**SECTION 00 63 57 – CHANGE ORDER REQUEST FORM**

City of Port Lavaca City Hall Phase 4: Interior Renovations & Security Upgrades  
 Project Name

## CHANGE EVENT #001 - ASI 01

ARCHITECT'S SUPPLEMENTAL INSTRUCTIONS

**A1 FLOOR PLAN**  
1/4" = 1'-0"

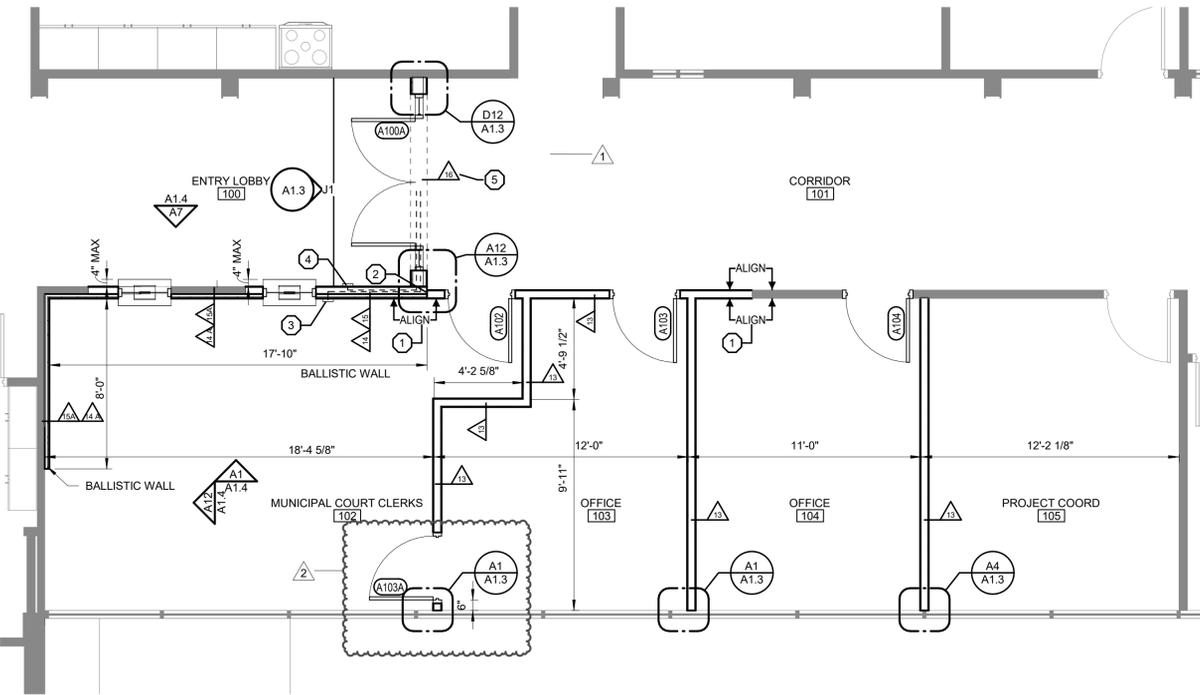
**Description:** Please see the attached pricing and backup documentation associated with ASI 01. Scope includes adding A103A opening to the project with a new hollow metal frame, plastic laminate door, and hardware set.

1. Revised Architectural drawings A1.1 and A1.3 showing additional door added between OFFICE 103 and OFFICE 102. Door to receive HARDWARE SET 02 as indicated in Section 08 70 00 of the project specifications
